**RICHLAND COUNTY
PLANNING COMMISSION**

FEBRUARY 3, 2004

Agenda

SD 04-162
BROOKHAVEN, PHASE 2
TMS 17500-03-42

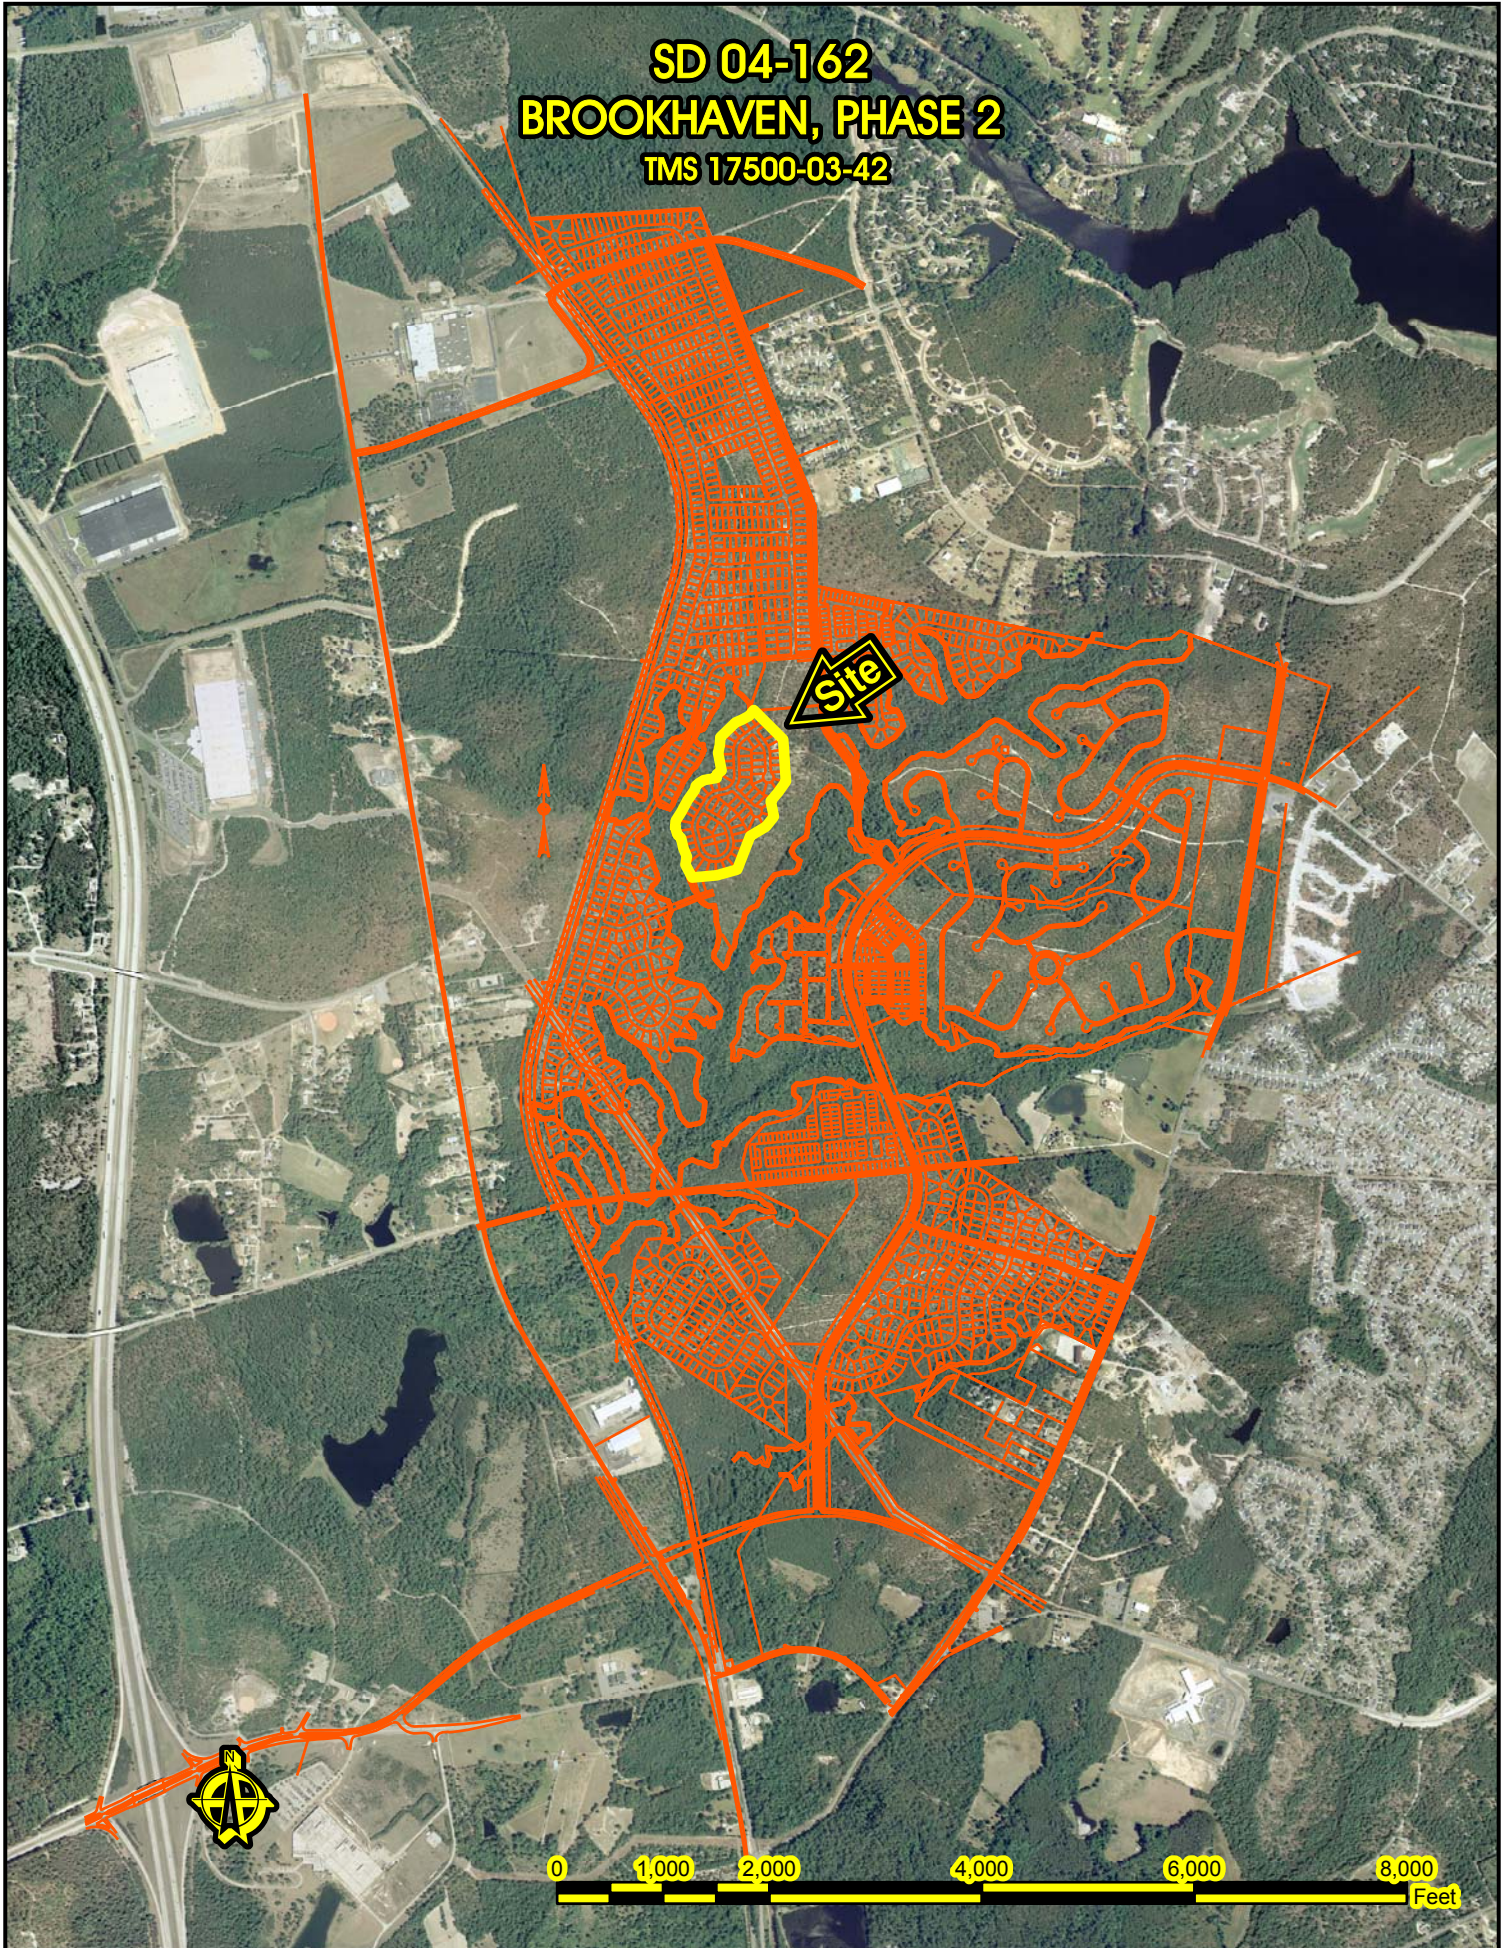
The **proposed subdivision is not consistent** with the Proposed Land Use Map because it is a residential project located in an area designated for industrial development. The state law requires projects to be consistent with the provisions of the Comprehensive Plan, including the Map. **Even though the County rezoned the entire project to PUD-2, the I-77 Corridor Subarea Plan Proposed Land Use Map was not changed to a residential as required by state law.**

- 1) As of January 21, 2004, the Department had not received the Public Works Dept. approval of the stormwater management plans.
- 2) As of January 21, 2004, the Floodplain Manager had not approved the flood elevation statement.
- 3) As of January 21, 2004, the City of Columbia had not approved the water and sewer line construction plans.
- 4) As of January 21, 2004, DHEC had not issued a construction permit for the sewer lines.
- 5) As of January 21, 2004, DHEC had not issued a construction permit for the water lines.

- b) The Department of Public Works must approve the stormwater management plans; and
- c) The Floodplain Manager (Harry Reed @ 576-2150) **must approve the flood elevation statement prior to building permits being issued**; and

- d) The City of Columbia must approve the water and sewer line construction plans; and
- e) DHEC must issue the sewer line construction permits; and
- f) DHEC must issue the water line construction permits; and

SD 04-166
PINE KNOLL (MINOR)
TMS 06201-07-10

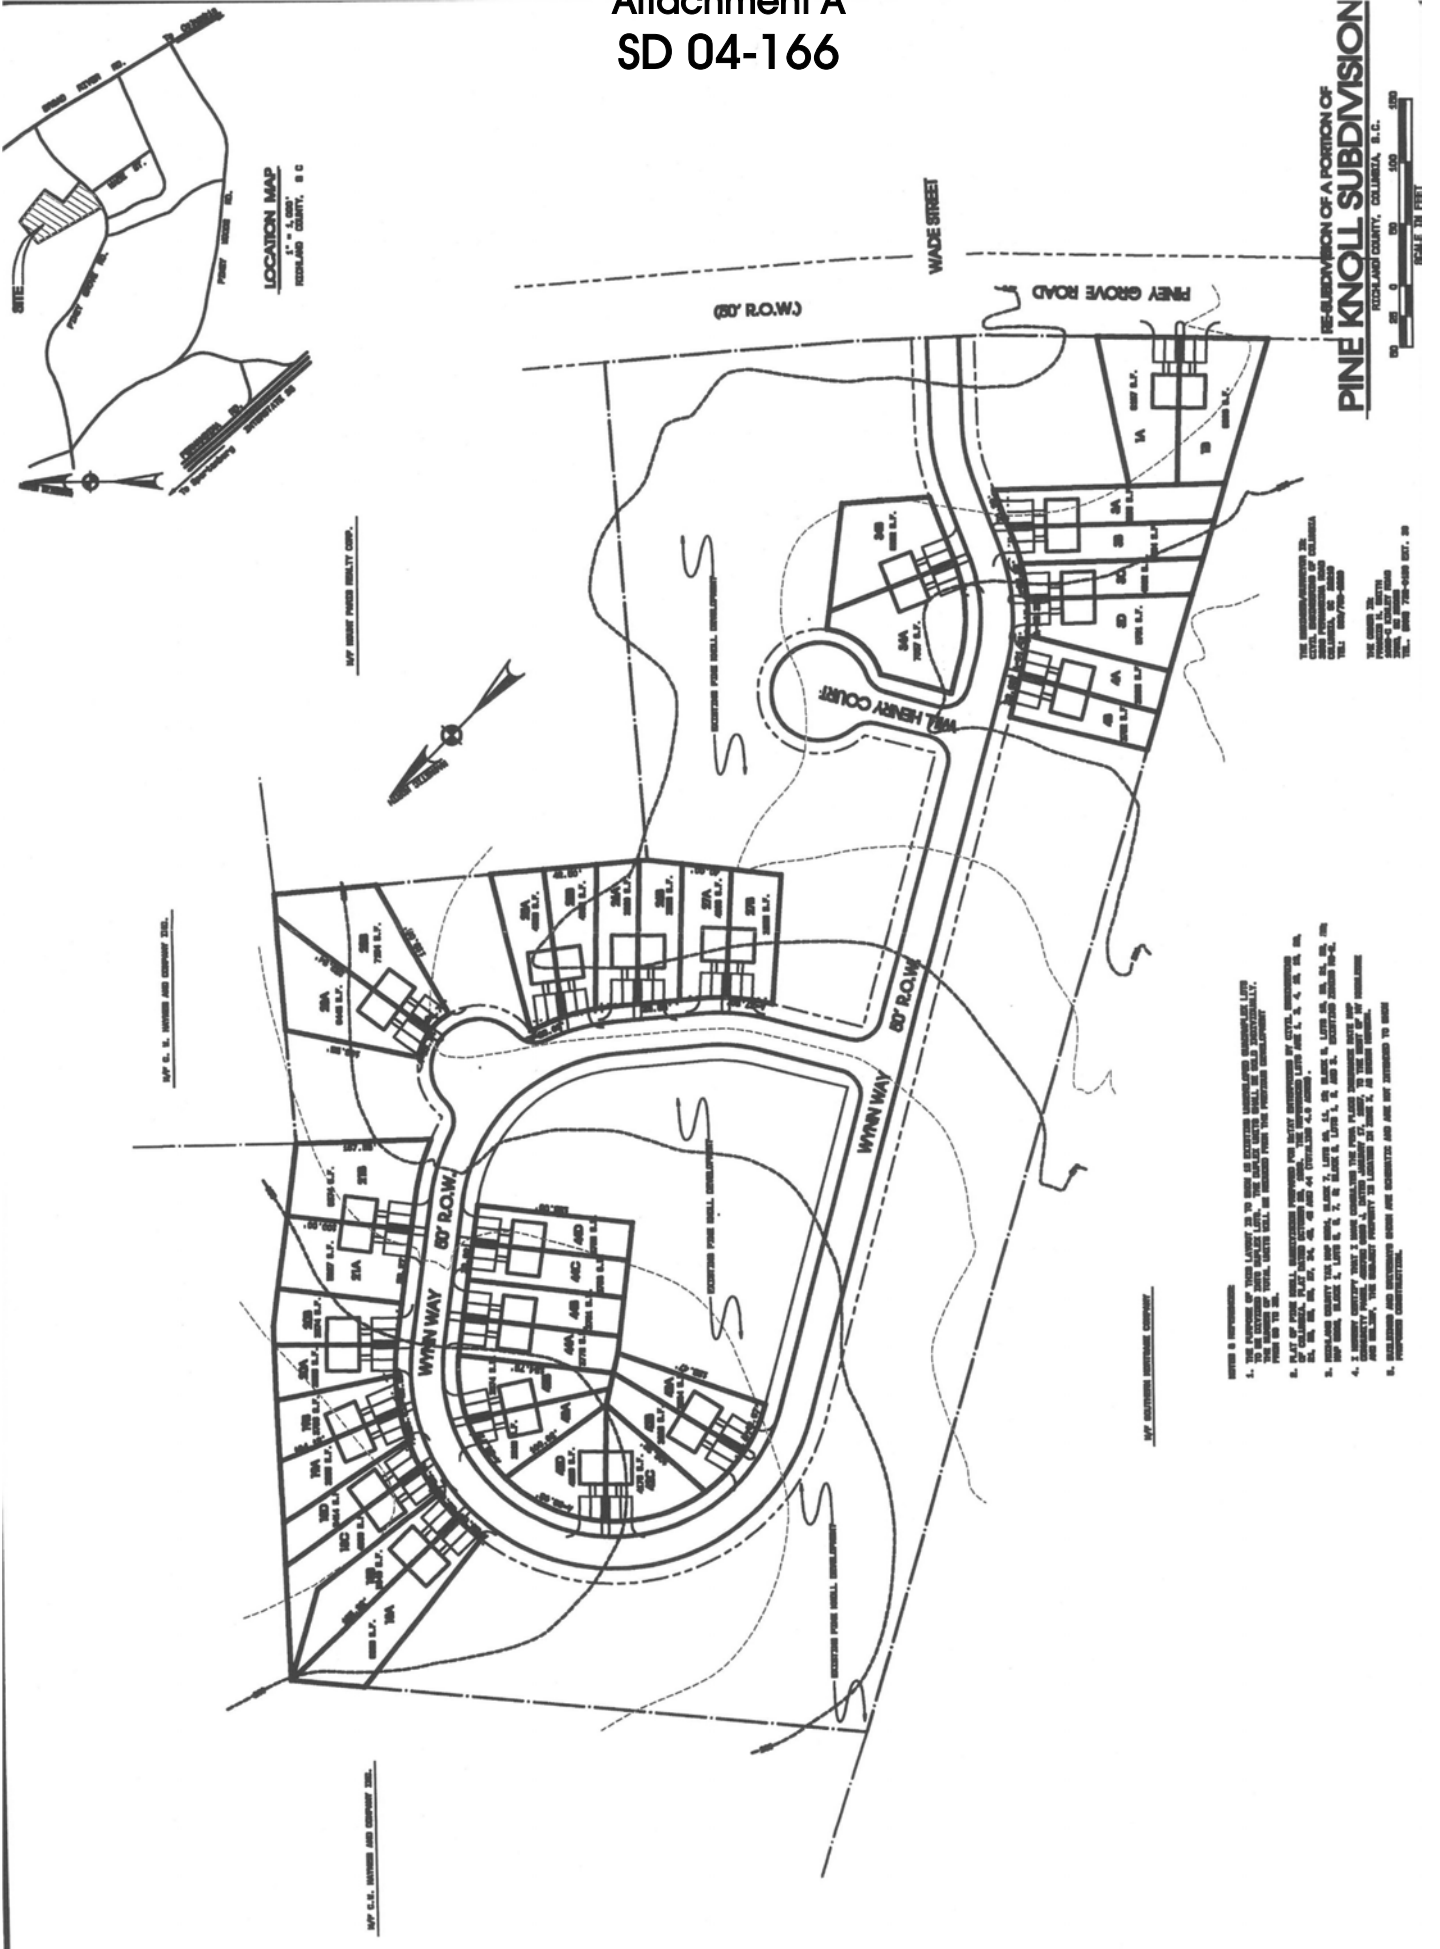
The Northwest Subarea Plan Proposed Land Use Map was amended on May 3, 1999 as part of the Plan adoption process. The subject site is designated as High/Medium Density Residential (**max. density of 9 DU/acre**) on this Map. The proposed project **is not consistent** with this land use designation as submitted.

The proposed project will result in the site exceeding the 9 DU/acre density limit established in the Subarea Plan, i.e., 38 units on 4.0 acres. **Therefore, the project does not implement this Principle.** However, if two units are eliminated from the project (see the discussion below), the proposed project would meet the 9 DU/acre density limit.

- 1) As of January 21, 2004, the Public Works Dept. had not approved the stormwater management plans.
- 2) As of January 21, 2004, the flood elevation statement had not been approved.
- 3) As of January 21, 2004, the City of Columbia had not approved the water line construction plans.
- 4) As of January 21, 2004, DHEC had not issued a sewer line construction permit.
- 5) As of January 21, 2004, DHEC had not issued a water line construction permit.

1. The traffic generated by the proposed subdivision, by itself, will not result in the adjacent portion of Piney Grove Road operating below a LOS C capacity.
2. Lot 1 shall be prohibited from having direct access to Piney Grove Road.
3. The proposed subdivision is compatible with existing development in the area.
4. The proposed project is consistent with the Northwest Subarea Plan Map land use designation.
5. The proposed project implements the relevant Objectives and Recommendations of the Northwest Subarea Plan.

- b) The plat must establish the setbacks, either graphically or by notation, for each lot; and
- c) The Department of Public Works must approve the stormwater management plans; and

- d) The Floodplain Mgmt. Specialist must approve the flood elevation statement prior to building permits being issued; and
- e) The City of Columbia must approve the water line construction plans, if necessary; and
